RA6M5 Group

Evaluation Kit for RA6M5 Microcontroller Group
EK-RA6M5 v1
Errata

EK-RA6M5 v1 – Errata

Figure 1. Breakout Pin Headers J1, J2, J3, J4

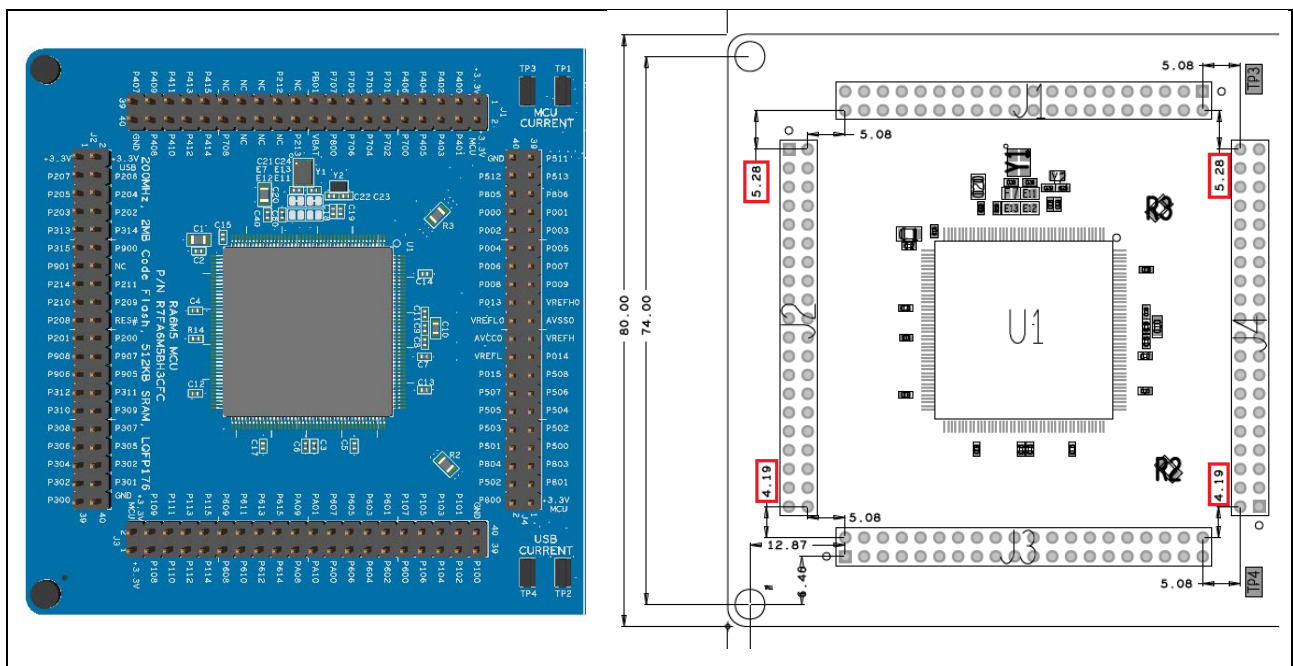
The breakout pin headers J1, J2, J3, and J4 on the EK-RA6M5 board should align to a 0.1” grid to enable the easy placement of any compatible piggyback board (general purpose prototyping board).

With reference to the dimensional drawing it can be seen that J1 and J3 are not aligned to the grid along one axis.

None. The breakout pin headers have been moved to align with the 0.1” grid on later builds of the board.

Figure 2. MCU UID Leading Zero Not Displayed

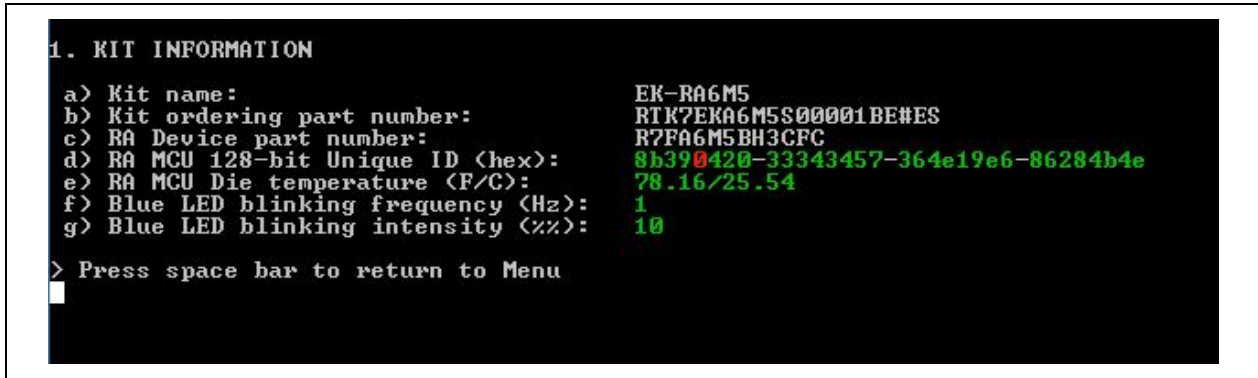
In certain cases the Quick Start Software programmed into the board may incorrectly display the device UID.

The UID is displayed in ‘Kit Information’ as a series of 4byte values *bbbb-bbbb-bbbb-bbbb* as can be seen in the example below. If any single byte is of the form ‘0000nnnn’ i.e. has a leading zero, it will not be displayed.

None. The Quick Start Software programmed into later boards has been updated to show the correct device UID.

Figure 3. USB High Speed series 33 Ω resistors (R83 and R84)

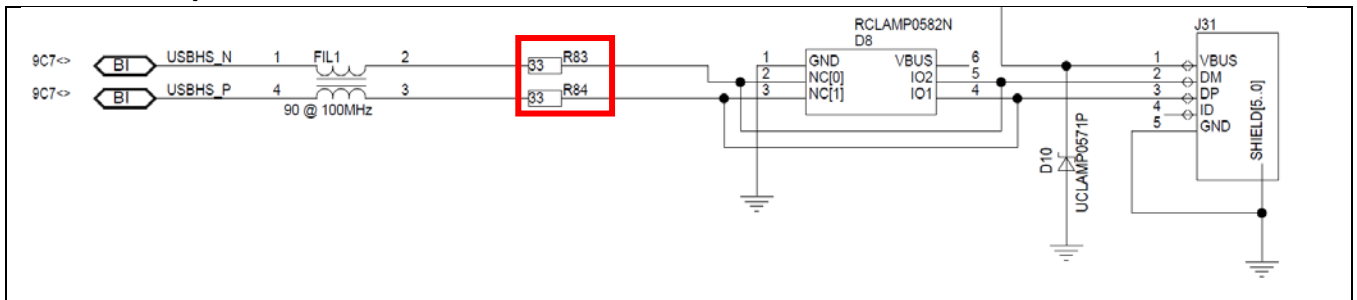
Both data pins of the USB high speed port (J31) are connected to the MCU via 33 Ω resistors (R83 and R84). This has caused issues with connection to USB 3.0 ports. Replacing these resistors with 0 Ω resistors fixes this issue.
